3. **Resolution No. 407 Frog Pond Overlook**

DEVELOPMENT REVIEW BOARD RESOLUTION NO. 407

Hearing Date:	g Date: September 12, 2022		
Date of Report:	September 1, 2022		
Application Nos.:	 DB22-0002 Frog Pond Overlook 12-Lot Subdivision Annexation (ANNX22-0001) Zone Map Amendment (ZONE22-0002) Stage 1 Preliminary Plan (STG122-0002) Stage 2 Final Plan (STG222-0002) Site Design Review of Parks and Open Space (SDR22-0002) Tentative Subdivision Plat (SUBD22-0001) Type C Tree Removal Plan (TPLN22-0001) Abbreviated SROZ Map Verification (SROZ22-0004) 		
Request/Summary:	The requests before the Development Review Board include Annexation, Zone Map Amendment, Stage 1 Preliminary Plan, Stage 2 Final Plan, Site Design Review of Parks and Open Space, Tentative Subdivision Plat, Type C Tree Removal Plan, and Abbreviated SROZ Map Verification		
Location:	7315 SW Frog Pond Lane. The property is specifically known as TLID 700 and a portion of SW Frog Pond Lane right-of-way, Section 12D, Township 3 South, Range 1 West, Willamette Meridian, Clackamas County, Oregon.

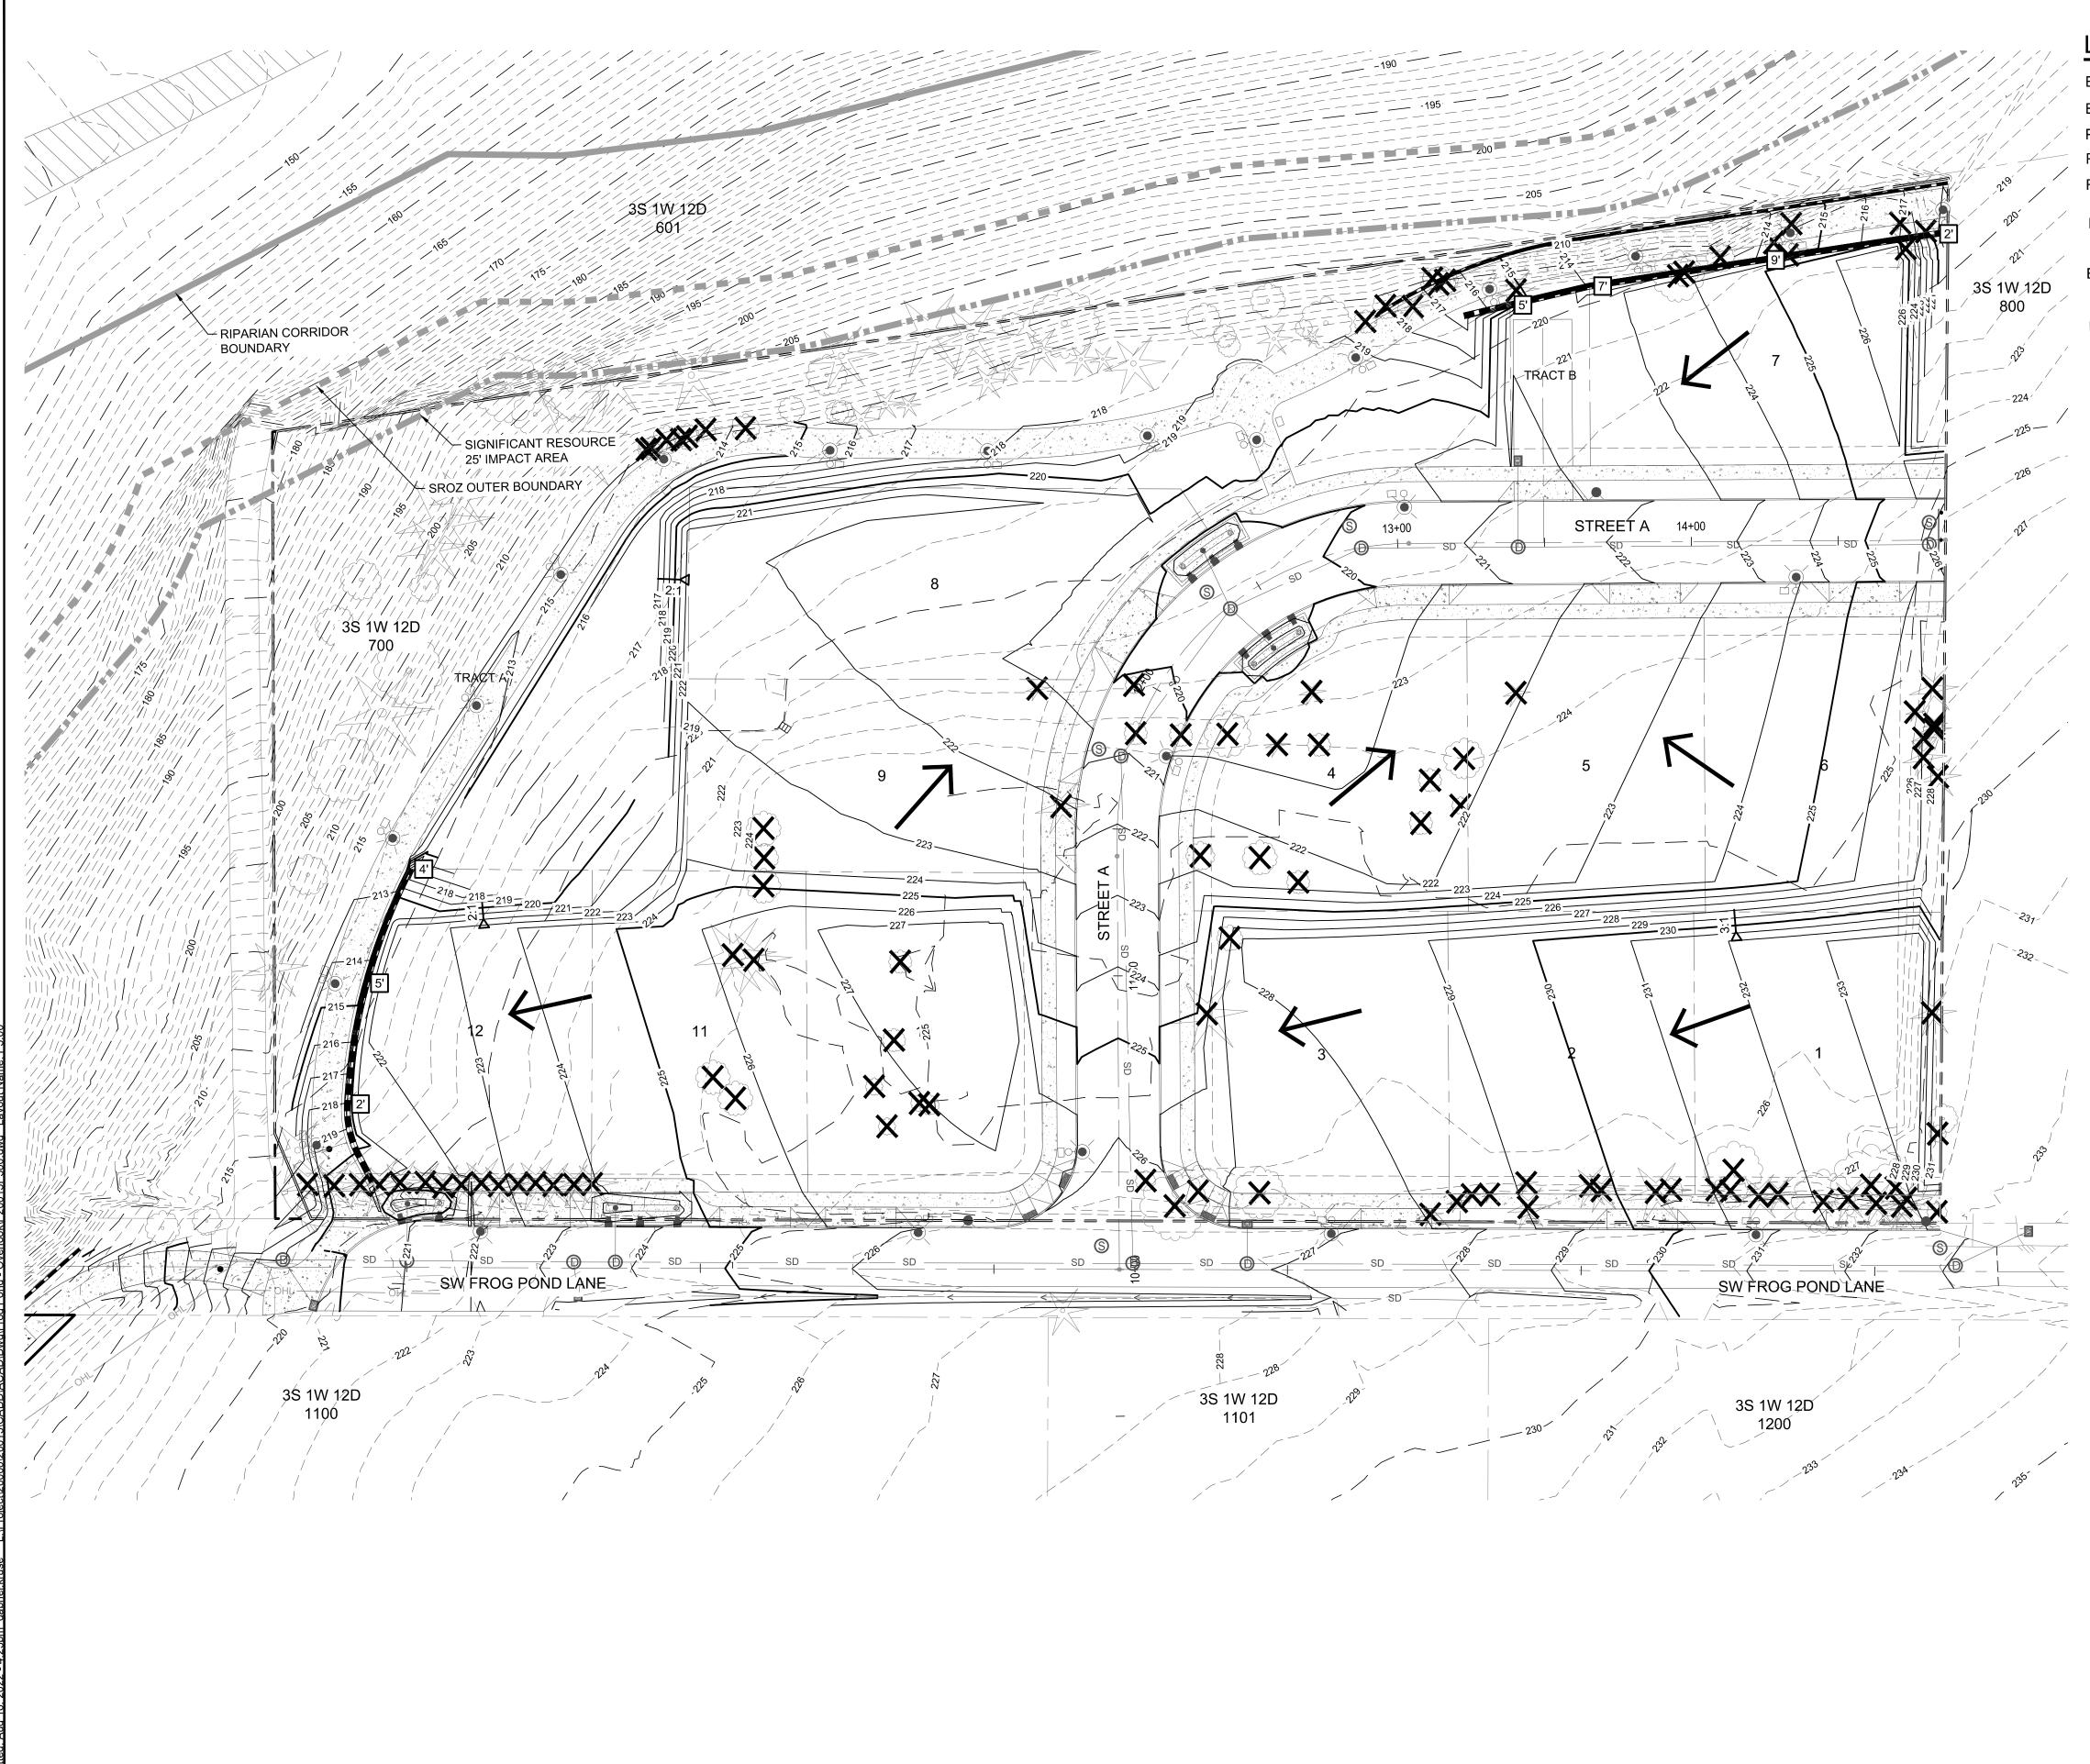
3. How many mitigation trees will be planted - as street trees, in Tract A, etc. - on-site?

Response: 27 street trees and 21 trees in tract A – 48 total

ed: Aug 16. 2022 - 4:23pm gabriel.kruse L:\Project\20000\20015\CADD\ACAD\Dwg\Frog Pond - Overlook\P20015P500.dwg Lavout Name: P5.00

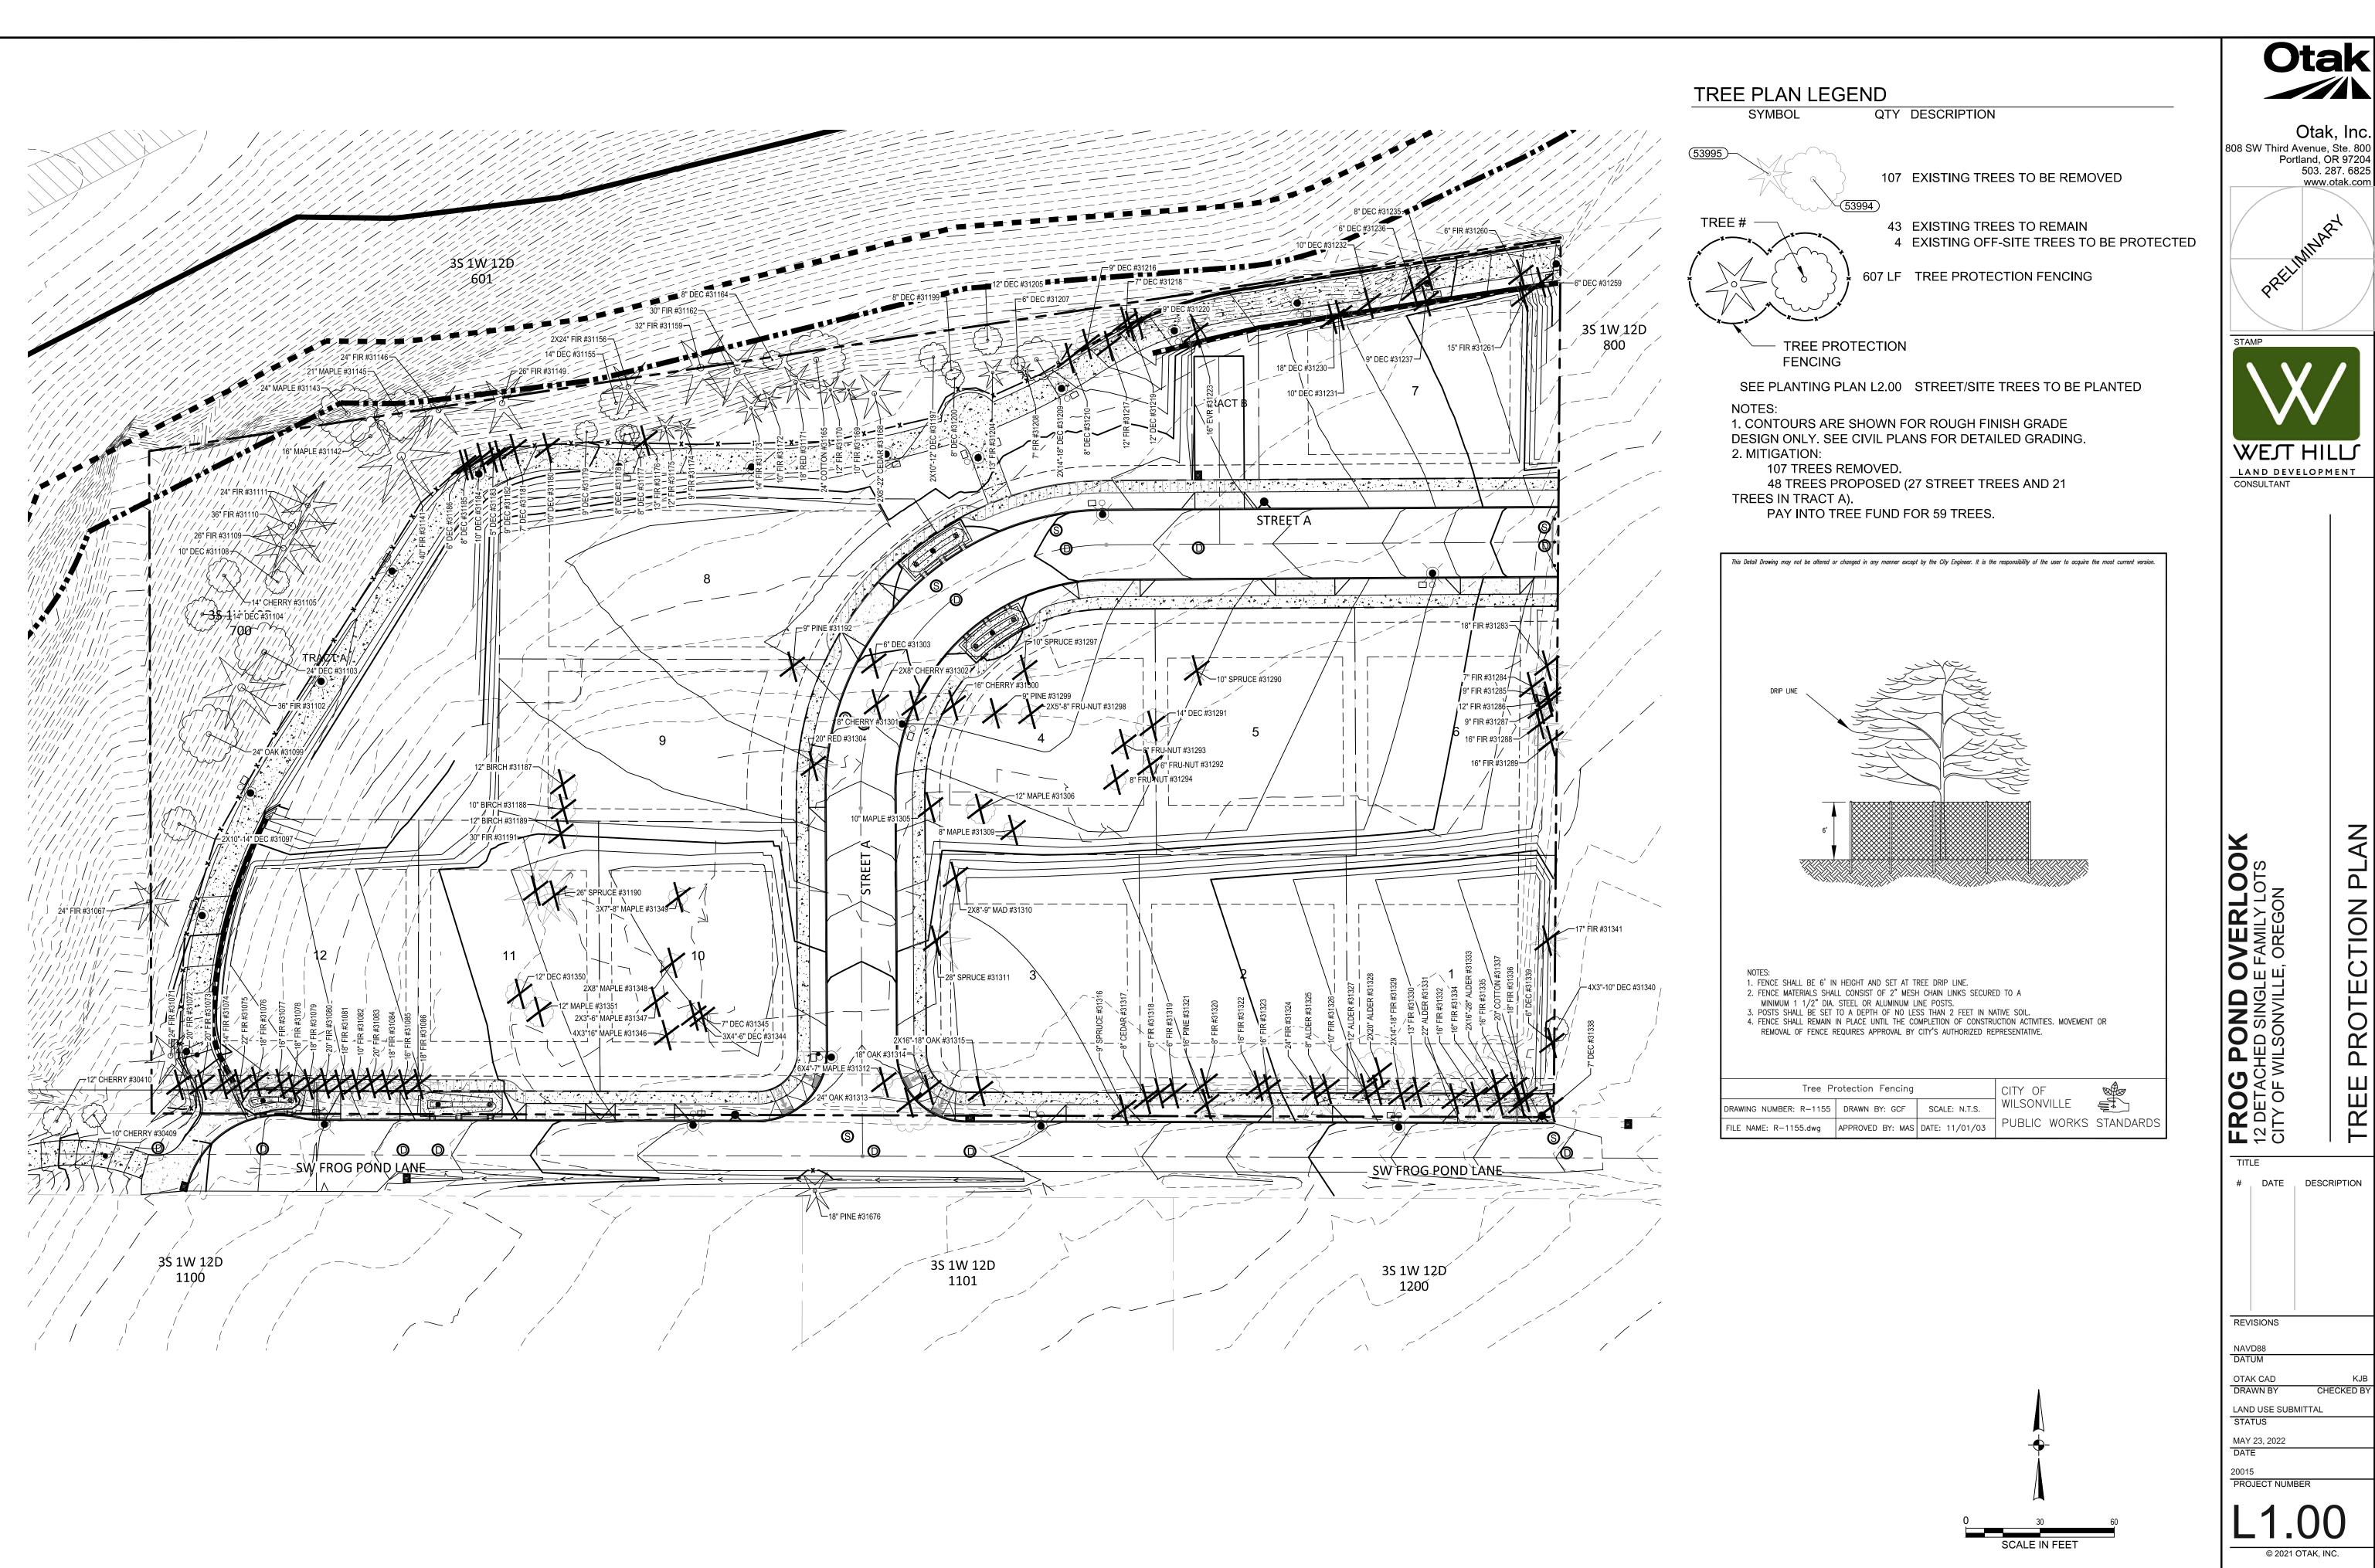
This memo provides additional information and clarification of the submitted land use application materials in response to questions from the City. City questions are in *italics*. See also updated Sheets P5.00, L1.00, and L1.10.
